April 11, 2022

SUBJECT: Response to *Additional Site Investigation Work Plan*
JCI/Tyco FTC PFAS, 2700 Industrial Parkway South, Marinette, WI
BRRTS #02-38-580694

In this letter, the DNR approves the SI Work Plan and provides JCI/Tyco with recommendations for additional monitoring for the field investigation and evaluations to include in the status report following the field work.

Figure 5 from SI Work Plan
Groundwater Monitoring Locations
DNR Recommendations A to H Added to Figure

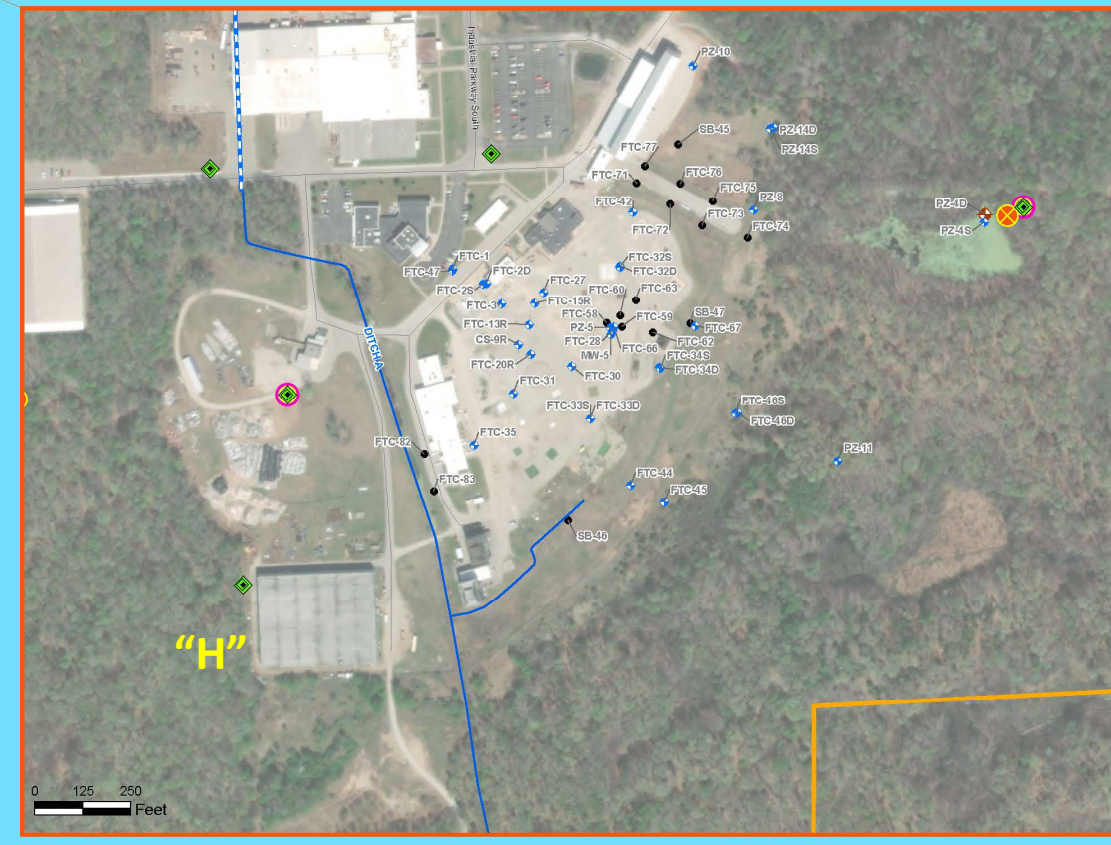
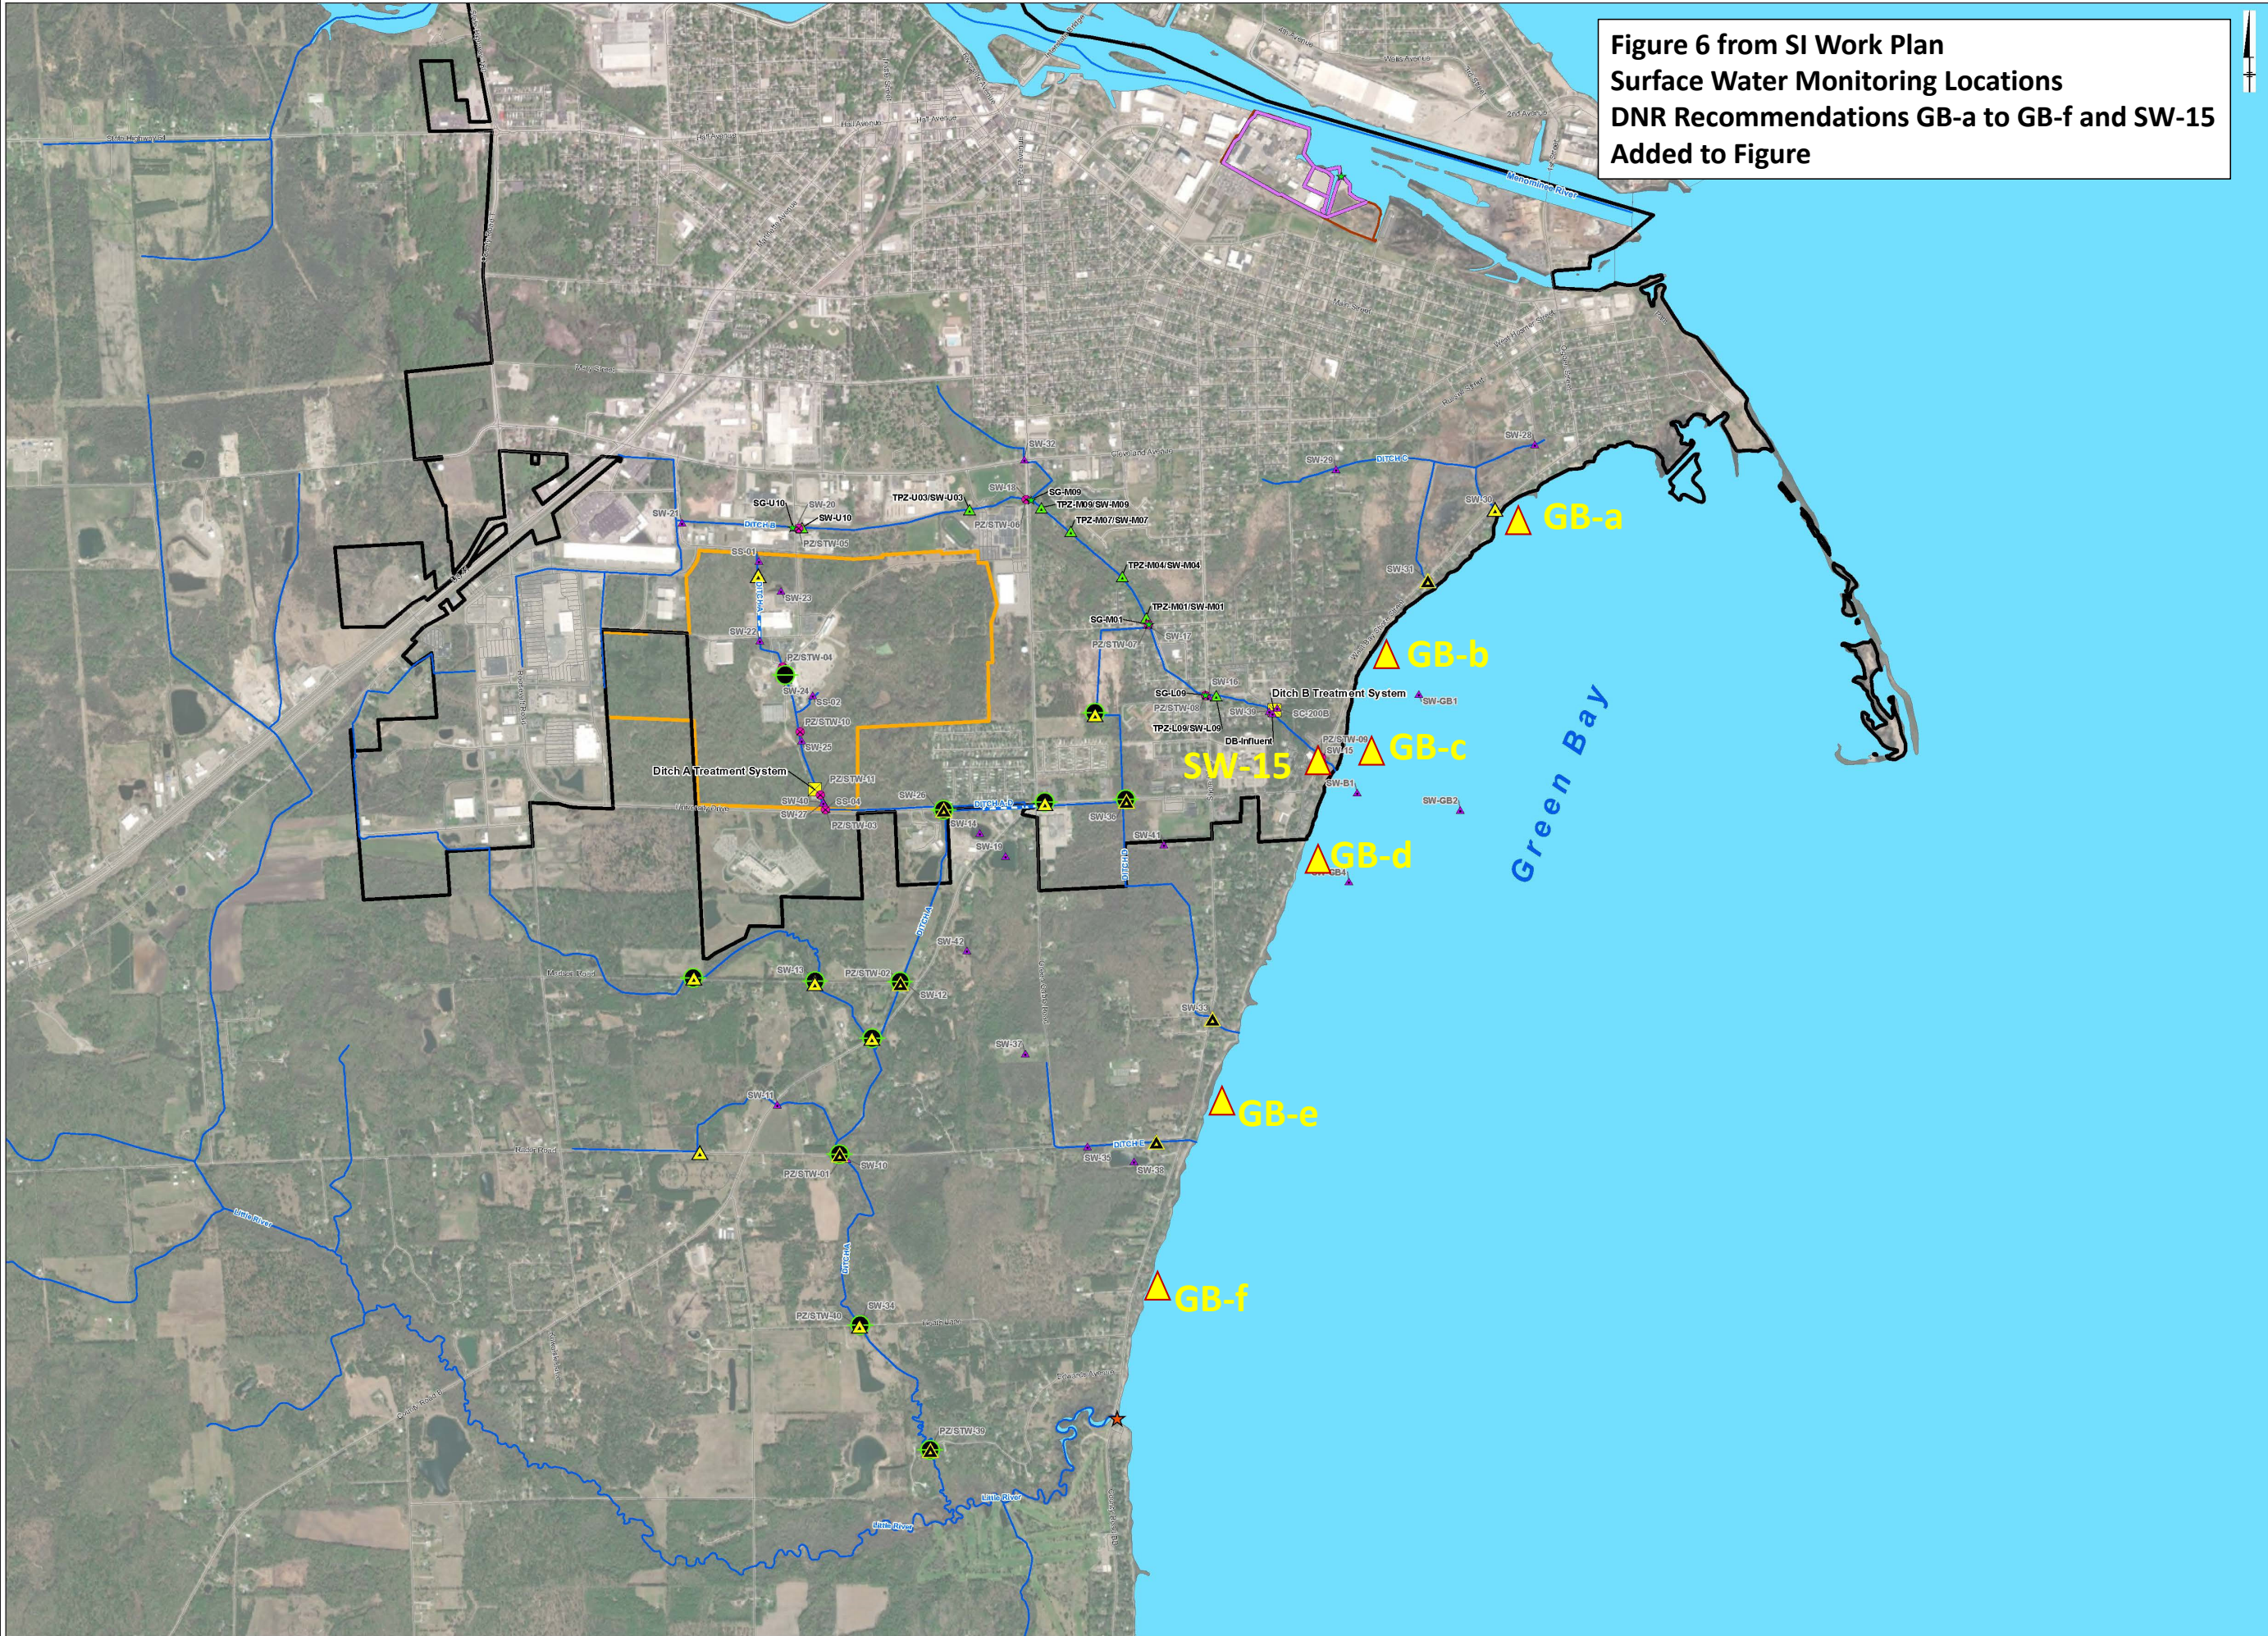
Recommended Actions	Data Objective(s)	Basis of Recommendation
Install and sample additional NR 141 well(s) in overburden at A to E .	<p>Assess plume stability and attenuation.</p> <p>Delineate the eastern and vertical extent of the plume.</p>	<p>Much of the off-site groundwater plume was interpreted from the results of a one-time sampling event from VAPs. NR 141 monitoring wells are recommended in additional locations in the interior and eastern/southeastern portions of the plume to assess stability and attenuation and to define the extent of the contamination. The eastern extent of the groundwater plume is needed to characterize the flux of PFAS from groundwater to Bay of Green Bay.</p> <p>Because the overburden thickens to over 75 feet to the south and east of the FTC, and because the highest concentrations detected on-site were detected at a depth of approximate 50 feet bgs, wells nested at various depths are needed to characterize the plume.</p>

Install and sample additional NR 141 well(s) in overburden and shallow bedrock wells at F and G	<p>Delineate the southwestern portions of the plume</p> <p>Assess if losing conditions in Ditch A resulted in impacts to groundwater</p>	<p>Previous exploratory sampling at VAP-01 and VAP-09 identified PFAS in groundwater near sections of Ditch A that were observed to have losing stream conditions. These areas also align with the steep bedrock ridge slope running southwest from the site. Additional NR 141 well(s) at F can be used to evaluate if losing conditions of Ditch A contributed to PFAS in groundwater detected at VAP-09 and wells paired at F and G can be used to evaluate potential for PFAS migration along the bedrock slope.</p>
Measure the depth of HWM wells located near Building 115 and sample select wells for PFAS (Area “ H ”).	<p>Delineate the PFAS concentrations in the overburden.</p> <p>groundwater on-site west of the OTA</p>	<p>The groundwater to the west and south of Building 115 has not been tested for PFAS, and existing monitoring wells present in this area provide an opportunity to characterize this area. Sampling a few of these wells (e.g., HWM-2-3S, -2-3D, and -5) during the preliminary groundwater monitoring event could supplement and strengthen the conclusions from the proposed VAP sampling in this area. If HMW wells are not sampled, additional VAP sampling is recommended in this area to the west of the OTA.</p>

Figure 6 from SI Work Plan
Surface Water Monitoring Locations
DNR Recommendations GB-a to GB-f and SW-15
Added to Figure

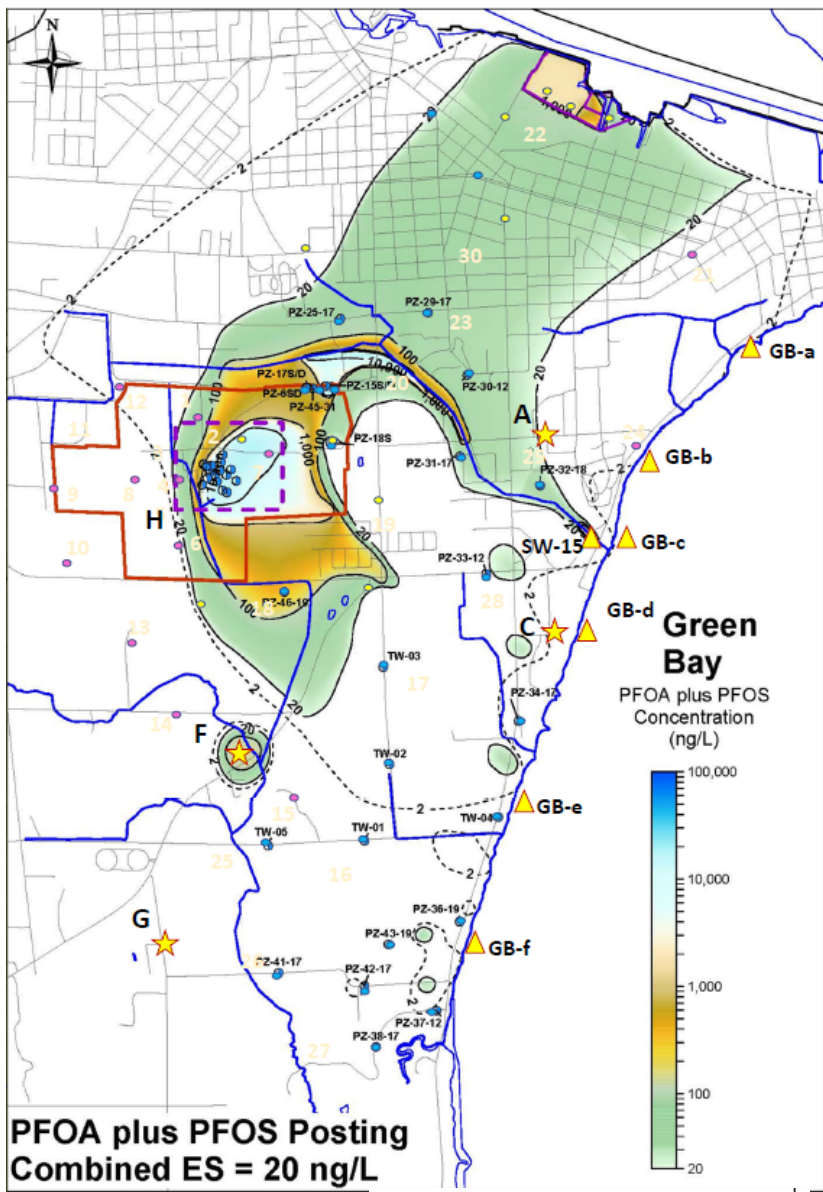
Include bi-monthly surface water sampling and stream gaging in Ditch B near SW-15 .	<p>Identify areas where surface water in ditches exceed standards.</p> <p>Evaluate seasonal range in conditions.</p>	<p>The DNR understands that surface water conditions in Ditch B will be evaluated during the long-term monitoring programs for the GETS and the Ditch B treatment system; however, it was also understood that portions of Ditch B downstream of SW-39 were not included in these remedial monitoring programs and would be included the SI field investigation. Direct measurements of the surface water quality at the outlet of Ditch B to Green Bay, collected at the same time as for the other ditches, is a key parameter in the characterization of the Site.</p>
Include seasonal surface water sampling (<i>and pore water</i>) at six near-shore locations in Green Bay (GB-a to GB-f).	<p>Show seasonal concentration range in surface water quality.</p> <p><i>(Evaluate PFAS flux to Bay of Green Bay)</i></p>	<p>Previous surface water testing in Green Bay near the outlet of Ditch B detected concentrations of PFAS at concentrations that would exceed current recommended standards. Additional testing is recommended to characterize PFAS in surface water along the shoreline of Green Bay that spans the outlets of the ditches and groundwater contaminated with PFAS from the FTC. <i>(Pore water sampling along the shoreline area may help to characterize the flux of PFAS to Green Bay from the groundwater).</i></p>
